**Re: FOUNDRY Filing 01 (#1696475) Public Improvement Plan Amendment**

**Amendment Justification**

**Figure 1. 2<sup>nd</sup> Round Redlines received for FOUNDRY Site Plan No. 1 at location of E. Warren Ave and E. Kewaunee St intersection.**

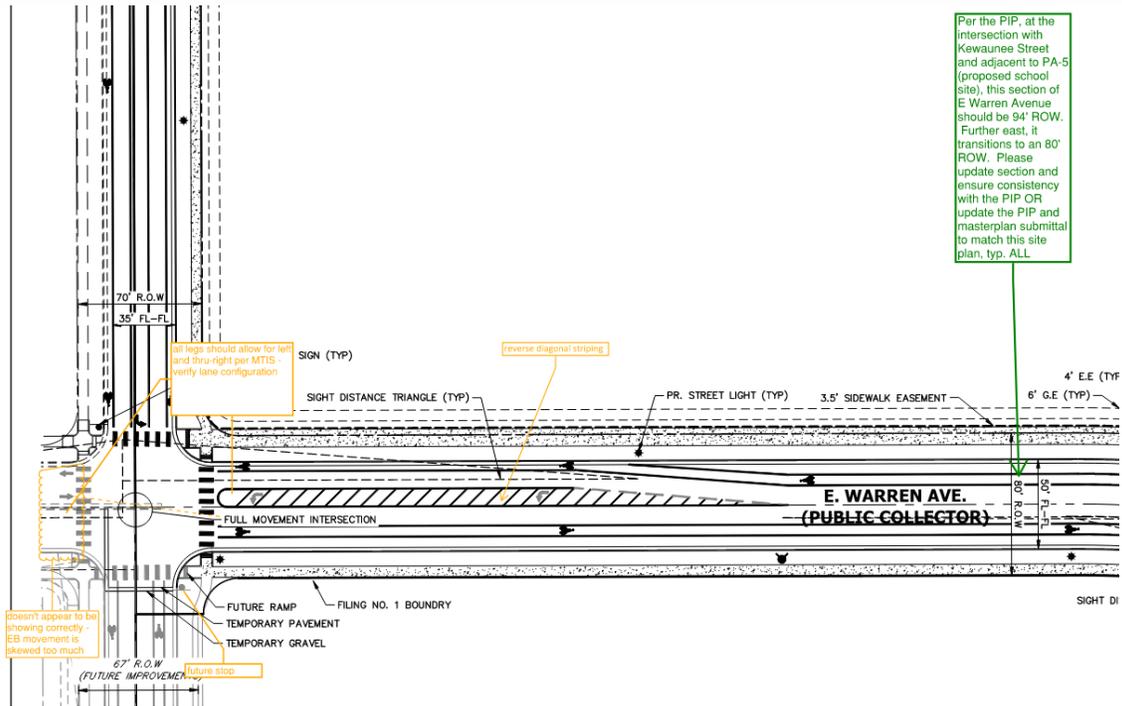
- Second Submittal Redlines (Dan Osoba Case Manager) two redline comments in yellow text from segomez (sheet 6 of 119): ***[first comment] all legs should allow for left and thru-right per MTIS - verify lane configuration. [second comment] doesn't appear to be showing correctly - EB movement is skewed too much.***
- Second Submittal Redlines (Dan Osoba Case Manager) one redline comment in green text from kanagam (sheet 6 of 119): ***Per the PIP, at the intersection with Kewaunee Street and adjacent to PA-5 (proposed school site), this section of E. Warren Avenue should be 94' ROW. Further east, it transitions to an 80' ROW. Please update section and ensure consistency with the PIP or update the PIP and master plan submittal to match this site plan, typ. ALL.***

The first two submittals of FOUNDRY Site Plan No. 1 included a 94-foot ROW for E. Warren Avenue in the location referenced in the comment by kanagam above. Because the traffic comments at the intersection of E. Warren Avenue and E. Kewaunee Street (see segomez comments above) required the addition of turn lanes to the 94-foot E. Warren Avenue ROW, the median that was included within the original 94-foot E. Warren Avenue ROW was reduced greatly to the point that a median was no longer viable as an entry feature in this location. In addition, the Warren Avenue section to the west of E. Kewaunee Street is 70-foot wide, so a transition from a 94-foot ROW to a 70-foot ROW across the intersection was challenging. Because of the traffic comments concerning turn lanes at the intersection of E. Kewaunee Street and E. Warren Avenue, the decision was made to utilize the 80-foot ROW section found in the FOUNDRY PIP for this section of E. Warren Avenue.

**Figure 2. 2<sup>nd</sup> Round Redlines received for FOUNDRY Site Plan No. 1 at location of roundabout.**

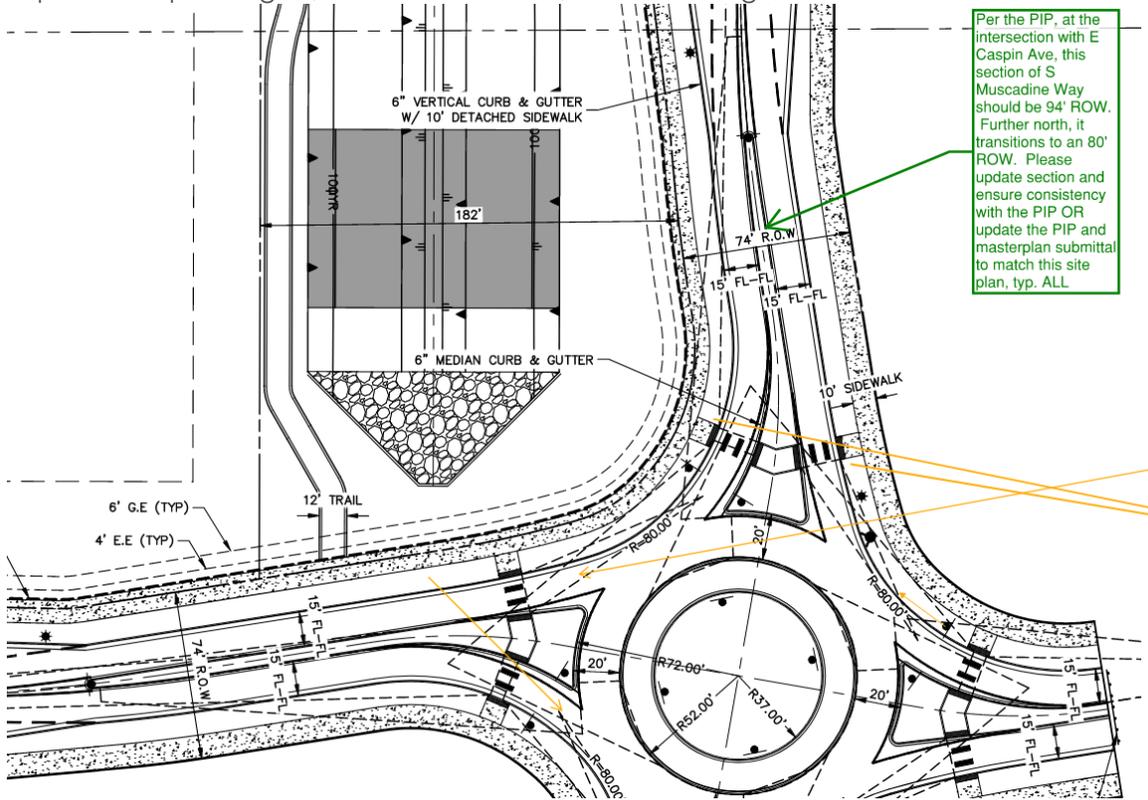
- Second Submittal Redlines (Dan Osoba Case Manager) one redline comment in green text from kanagam (sheet 11 of 119): **Per the PIP, at the intersection with E Caspin Ave, this section of S Muscadine Way should be 94' ROW. Further north, it transitions to an 80' ROW. Please update section and ensure consistency with the PIP OR update the PIP and masterplan submittal to match this site plan, typ. ALL**

Per the PIP, at the intersection with E Caspin Ave, this section of S Muscadine Way should be 94' ROW. Further north, it transitions to an 80' ROW. Please update section and ensure consistency with the PIP OR update the PIP and masterplan submittal to match this site plan, typ. ALL

Upon review of the first submittal of FOUNDRY Site Plan No. 1, the design team at the direction of Carl Harline revised the intersection of S. FOUNDRY Way (formerly S. Muscadine Way) and E. Caspin Avenue to be a roundabout. Conversations with Carl Harline at Public Works indicated that the city preferred a roundabout over a traditional intersection. The original design utilized the 94-foot ROW section as S. FOUNDRY Way approached the intersection and the original design featured a large, landscaped square in the middle of the intersection. The roundabout was implemented at the

intersection instead, and it made the 94-foot ROW section for S. FOUNDRY Way no longer functional as the large median came in conflict with the roundabout design and impacted taper lengths, sidewalk locations, and site triangles.

The 94-foot ROW section was only proposed for the two locations discussed above and because it is no longer being used within FOUNDRY Site Plan No. 1, the city has requested it be removed from the FOUNDRY PIP. Conversations with Public Works and City Engineering have led to design changes within Site Plan No. 1 that no longer required the use of the 94-foot ROW.
